FINAL ORDER

REQUEST FOR WRITTEN APPROVAL TO USE CONSTRUCTION METHODS NOT INCLUDED IN OREGON ADMINISTRATIVE RULES 690-200 THROUGH 690-240

(2) Start Card Number(s)(for work to be done): 174622

- (7) Diagram showing the pertinent features of the proposed well design and construction:
(attach additional pages if needed)

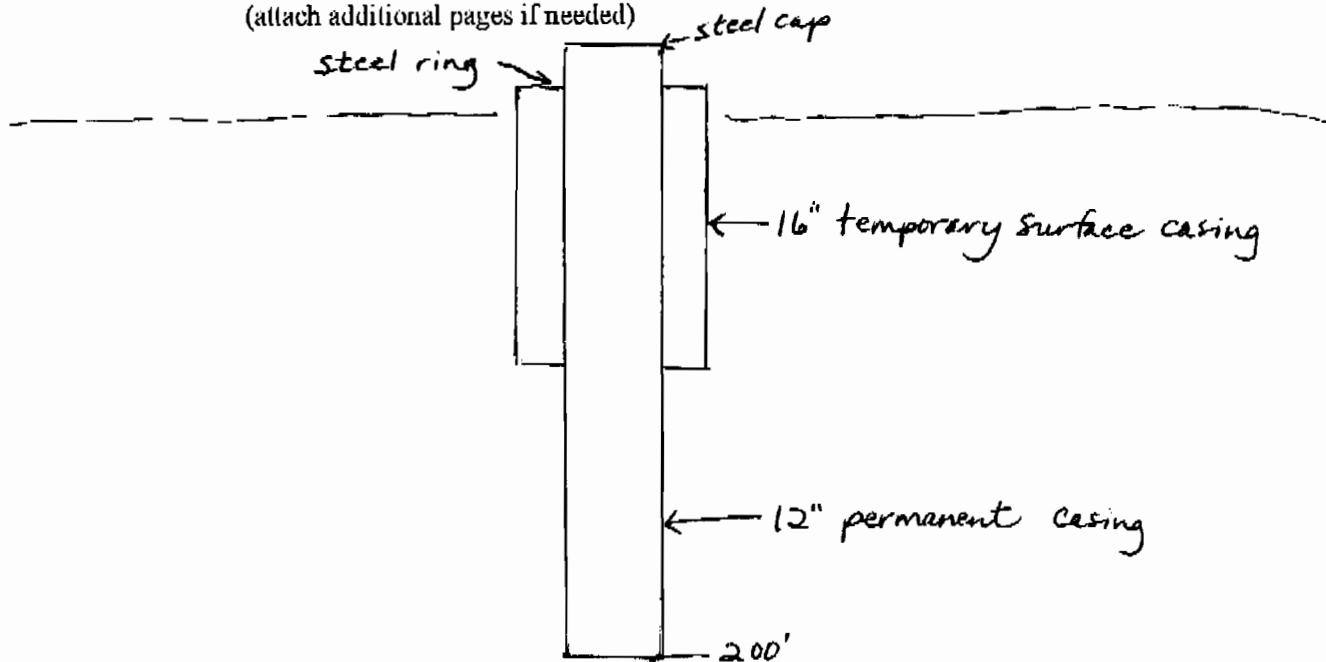
1) 16" temporary surface casing installed to 90'+.

2) 12" permanent casing installed to 200' +/-.

3) Steel ring welded between 16"/12" casing.

4) Steel cap welded on 12" casing.

5) Drilling rig will be moved back on well no later than June 1, 2005.

The Special Standard request you submitted for owner: Colony Nursery Inc, Start Card number 174622, is approved for the following: You may temporarily move your drilling machine off of this well site prior to completion of the well while you wait for the well screen to arrive. A steel plate shall be welded between the 16 inch temporary surface casing and the 12 inch permanent well casing to keep debris from entering the sealing interval. Also the well shall be properly covered by placement of a welded steel cap on the 12 inch casing. The drilling rig shall be moved back on site no later than June 1, 2005. This Special Standard was verbally approved on May 17, 2005.

Remarks: May Remove Drill Rig until 6/1/2005
